Motorola Mobility LLC.

Product Equality Declaration

The differences between EMEA DS (XT1762), EMEA SS(XT1761), APAC DS (XT1760) as below:

EMEA DS without NFC	EMEA SS with NFC
 Without NFC Antenna	 With NFC Antenna
 Without NFC Component	 With NFC Component

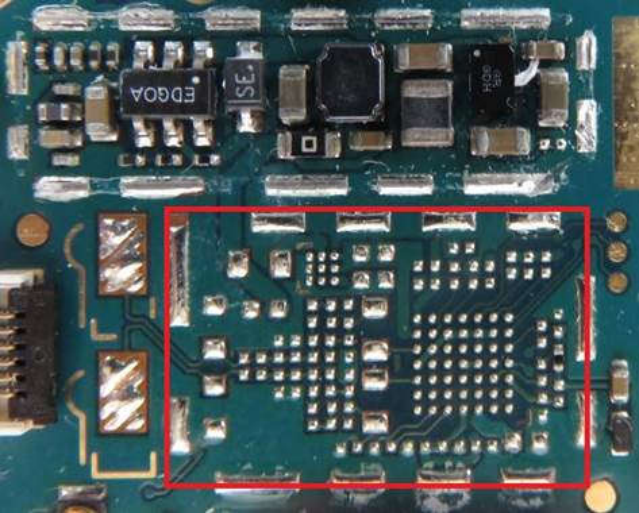
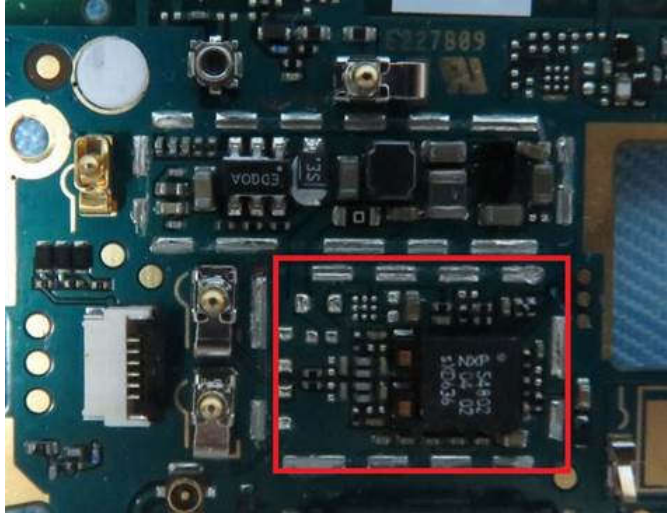
- HW section
- WCDMA/LTE bands: Difference of population/depopulation on duplex, SPDT Switch and matching capacitance inductance to enable support of different cellular bands.
- RF trace: same across EMEA DS (XT1762), EMEA SS(XT1761),APAC ,DS (XT1760) SKUs.
- PCB layout: same across EMEA DS (XT1762), EMEA SS(XT1761),APAC DS (XT1760), SKUs.
- PCBA: for any DS/SS models under the same SKU the same PCBA will be used. For example, EMEA DS/SS(XT1762/XT1761) will share the same PCBA and the only difference is that SS model will have only one SIM slot. PCBA of each SKU is unique because the RF components will differ from SKU to SKU.
- WLAN/BT/GPS/Diversity antenna type, antenna pattern, antenna location, antenna matching value and chipset: Same across EMEA, APAC, sku.
- NFC antenna type, antenna pattern, antenna location and chipset: Only EMEA SS(XT1761) SKU support NFC.
